**Case No. 2006.1073E**

# **THE EXPLORATORIUM RELOCATION PROJECT**

## **COMMENTS AND RESPONSES**

**DATE:** June 25, 2009  
**TO:** Members of the Planning Commission and Interested Parties  
**FROM:** Bill Wycko, Environmental Review Officer  
**RE:** Case No. 2006.1073E, Exploratorium Relocation Project  
Comments and Responses on the DEIR

THE EXPLORATORIUM RELOCATION PROJECT  
FIGURE C&R 10: EXPANDED PROJECT - NORTH AND SOUTH ELEVATIONS

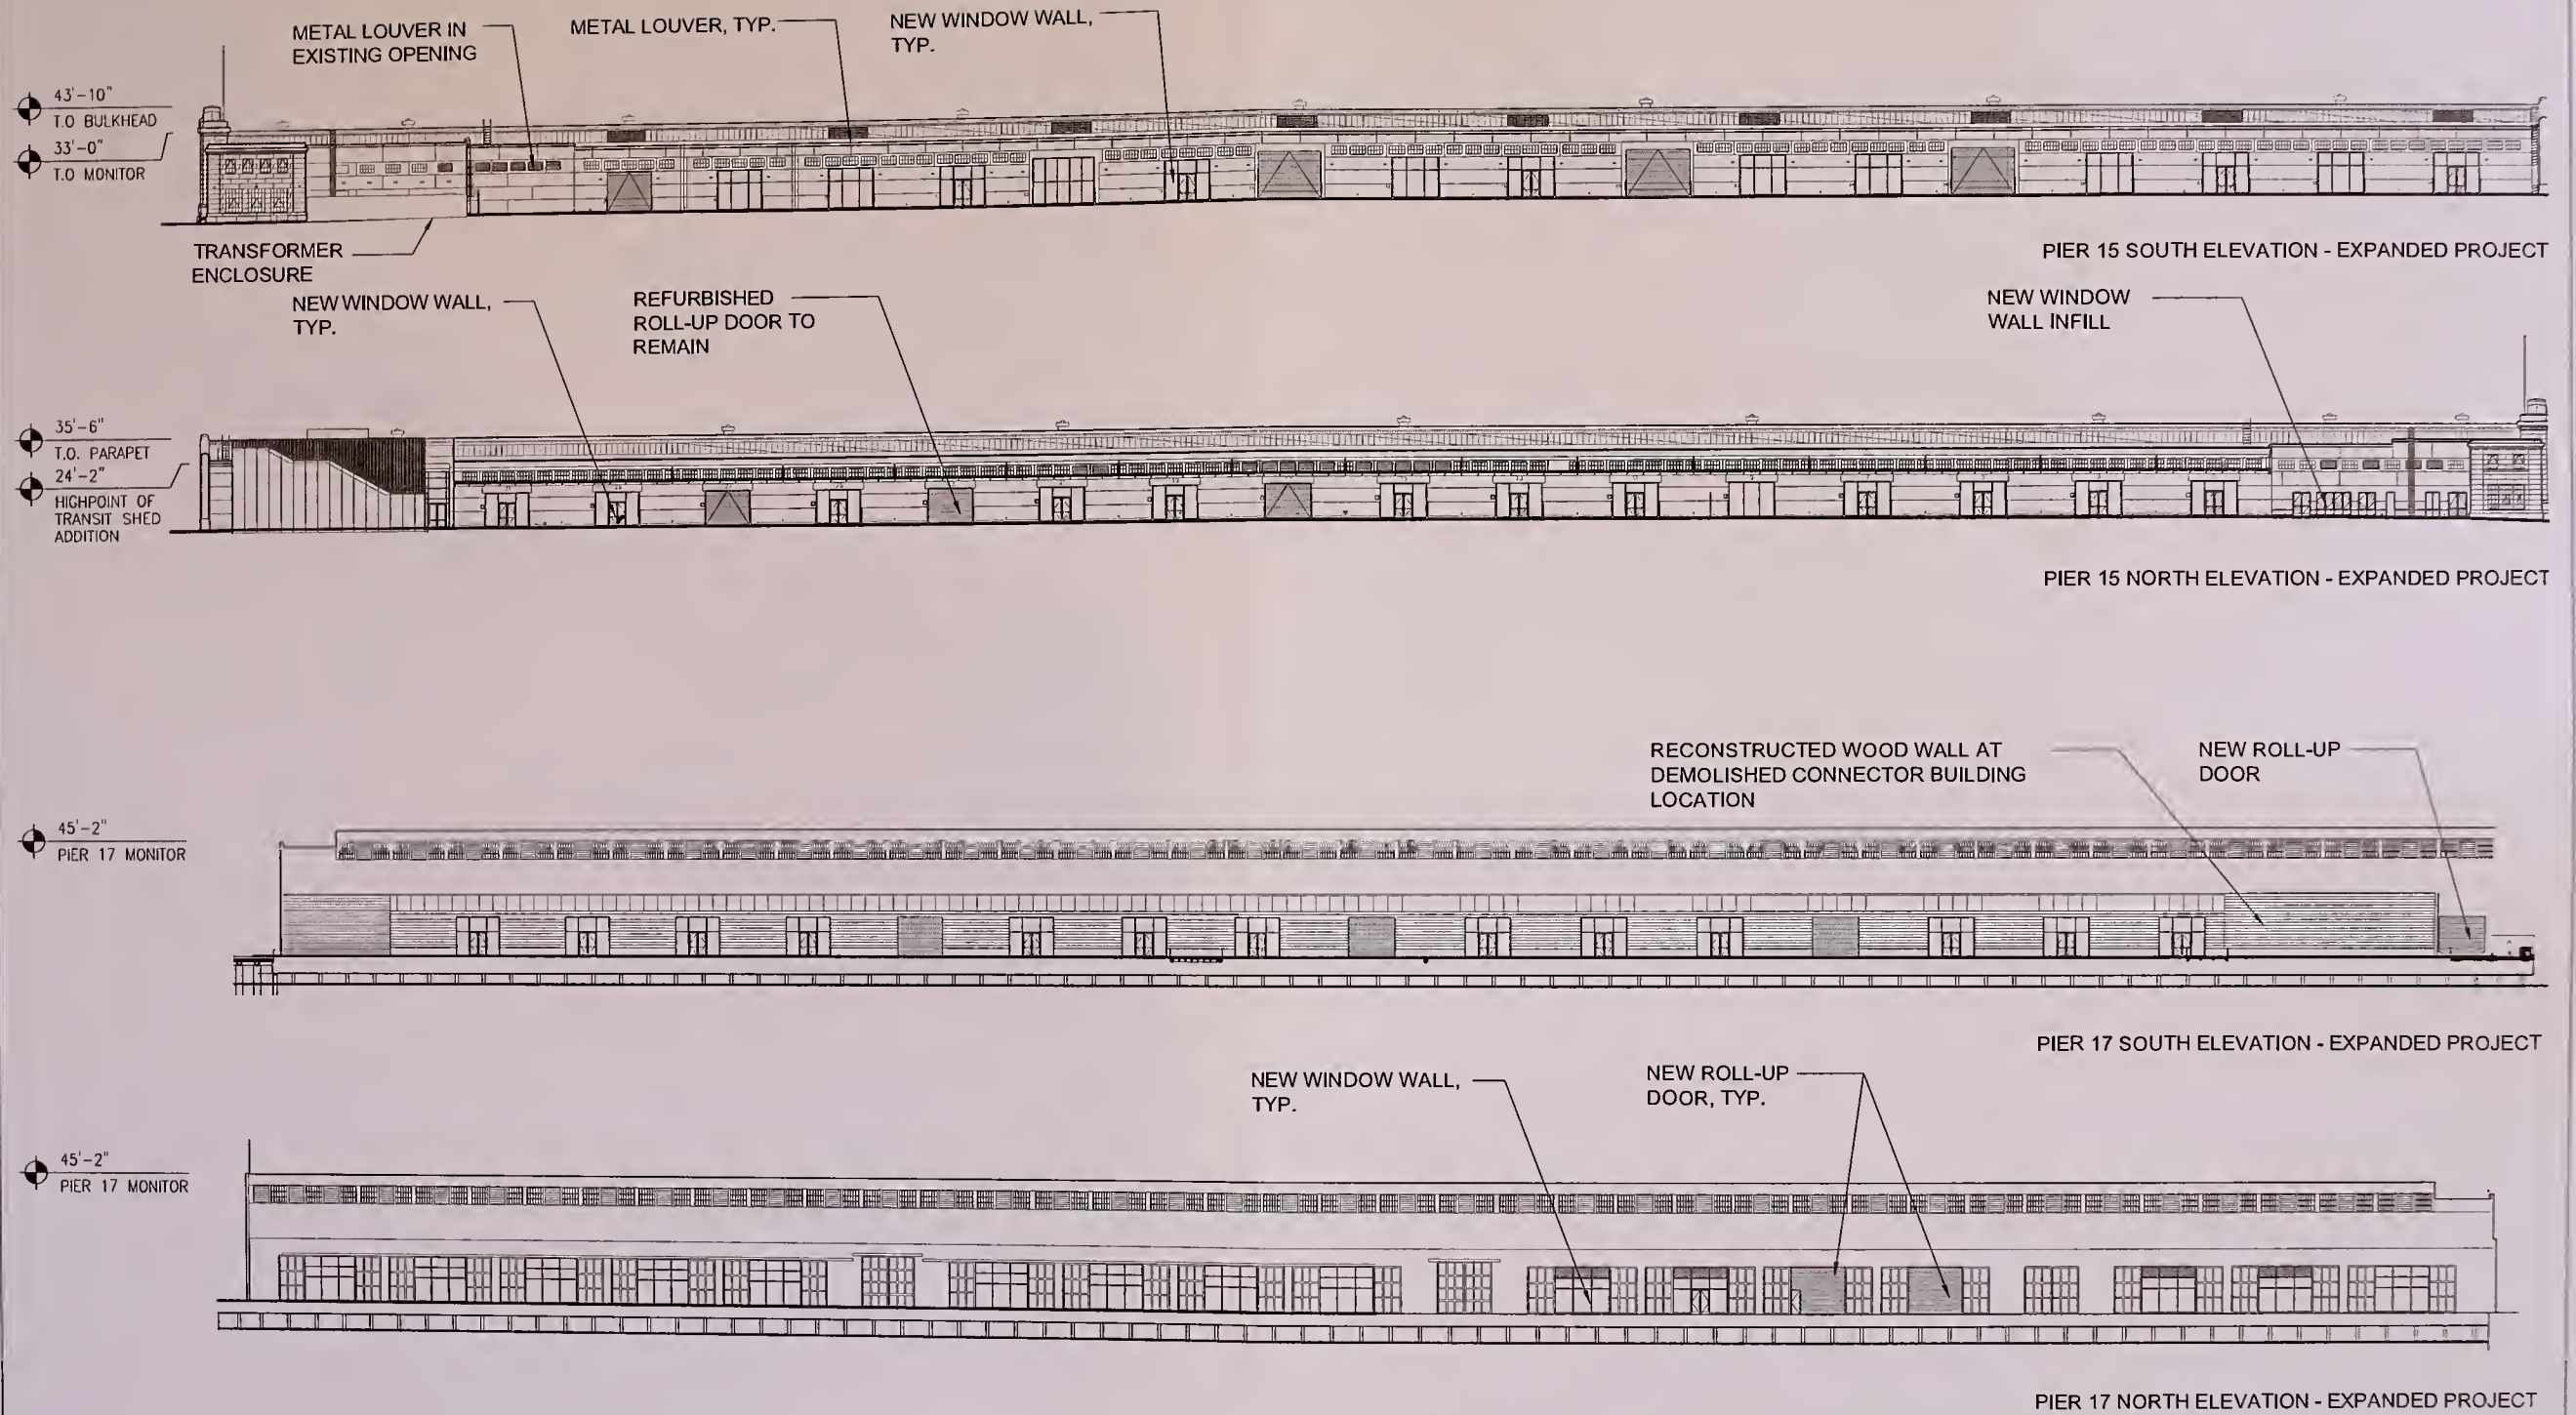
The proposed new Bridge Building is not adequately depicted nor fully described in the DEIR. The Draft EIR fails to adequately describe and depict the proposed new Bridge Building. There are no detailed drawings of this proposed new structure in the DEIR clearly showing the materials, architectural details or scaled height measurements in comparison to the existing historic sheds. The elevations are so pale as to not be readable (Figure 5) or they specifically state that the elevations are “not to scale” (Figure II-15). The photomontages contained at III.C-15 do not adequately show the proposed new Bridge Building and, because of the wide-angle lenses used for the basic image, these images are misleading and not at all informative. This appears to be a serious inadequacy of the DEIR. Without separate detailed presentations, there is no way the public or decision-makers could understand the potential impacts that the design of this building could have on historic resources and the aesthetics of our Waterfront. (*Vedica Puri, Telegraph Hill Dwellers, February 25, 2009*)

The commentors believe that the DEIR does not contain adequate graphics that accurately depict components of the Project and Expanded Project. The Project Description graphics have been revised to present details of the Project and Expanded Project more clearly. Additional graphics have also been included to illustrate the floor plans and building elevations for the Project and Expanded Project. The revised Project Description graphics are presented in Figures C&R-3 through C&R-10 on pp. C&R-35 through C&R-45 of this Comments and Responses document. These Figures will replace Figure II-3 through II-5 of the DEIR. Additional simulations of the Project and Expanded Project have been prepared to depict the Bridge Building as viewed from Herb Caen Way and the San Francisco Bay. Figure C&R-11, p. C&R-47 illustrates the locations of the new viewpoints and replaces Figure III.C-1, p. III.C-4 of the DEIR.

The note "not to scale" is a standard architectural term to alert the viewer that a physical architectural ruler (or scale) may not be used to measure building dimensions. However, the figures are accurately depicted relative to other elements within the drawing. The additional and revised graphics have clearer elevation marks depicting heights.
